AERONAUTICAL CHARTING MEETING
Instrument Procedures Group
Meeting 23-01 – April 24-25, 2023

RECOMMENDATION DOCUMENT

FAA Control #23-01-374

Subject: Definition of Vectors to Final Approach Course

Figure 1. VOR vectors to final.

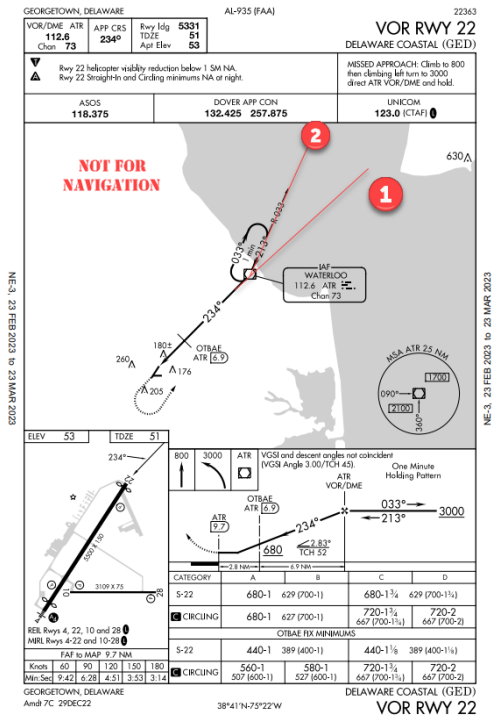
First, the GED VOR RWY 22 shown in Figure 1. If the pilot is given vectors outside of ATR to intercept the final, do they: intercept 234 (annotation #1) or intercept 213 (annotation #2)?

Figure 2. RNP Vectors to Final.

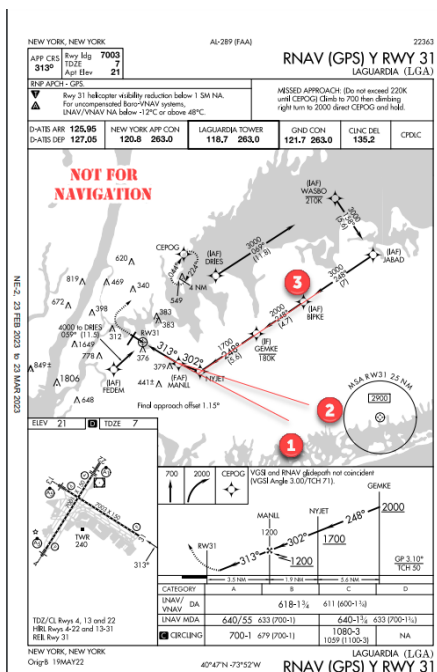
Next, the LGA RNAV (GPS) Y RWY 31 shown in Figure 2. In this RNP approach if the pilot is given a vector to intercept the final approach course, do they: intercept the 313 extension out of MANLL (annotation #1); intercept the 302 extension formed by NYJET to MANLL (annotation #2); or intercept the 248 extension formed by GEMKE (IF) to NYJET (annotation #3)?

Figure 4. RNP Vectors to Final with three potential options.

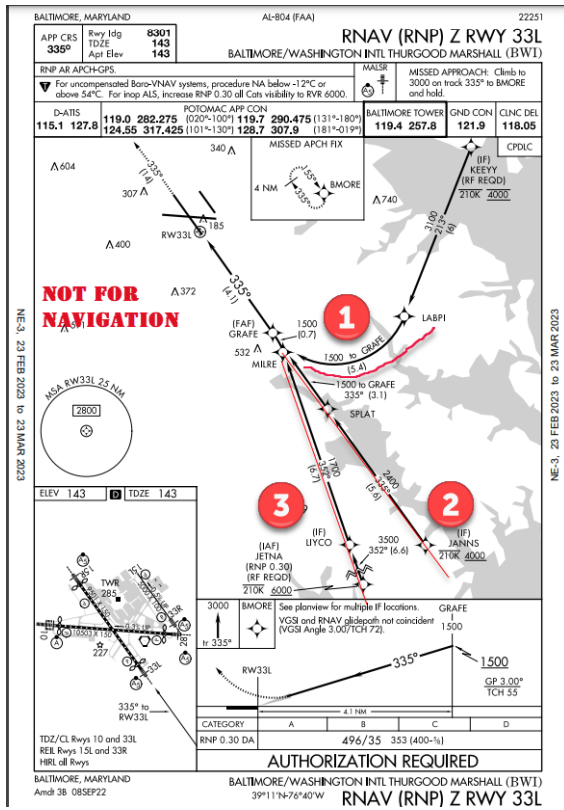
Next, the BWI RNAV (GPS) Z RWY 33L shown in Figure 4. In this RNP approach if the pilot is given a vector to intercept the final approach course, do they: intercept the RF leg from LABPI to MILRE (annotation #1); intercept the JANNIS to MILRE leg (annotation #2); or intercept the LIYCO to MILRE leg (annotation #3)? There may even be additional ambiguity by the small RF leg between MILRE and GRAFE (FAF).

Figure 5. RNP AR RF Vectors to Final.

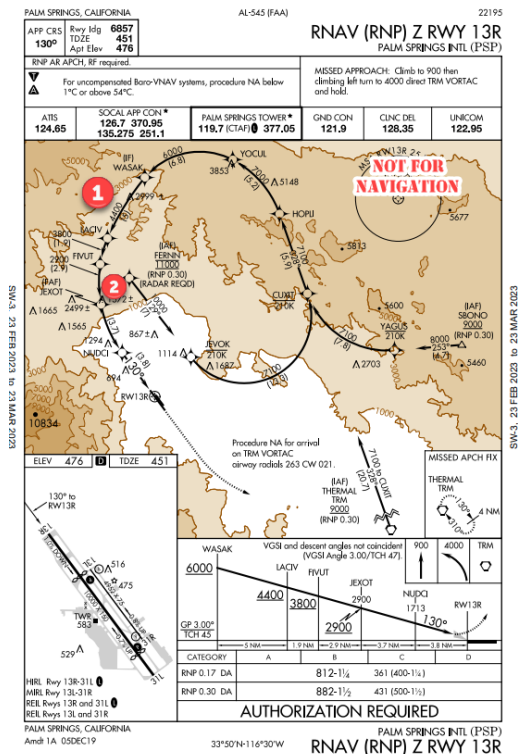
Lastly, the PSP RNP (RNP) Z RWY 13R shown in Figure 5. In this RNP AR with RF legs approach if the pilot is given a vector to intercept the final approach course, do they intercept at annotation #1 or annotation #2?
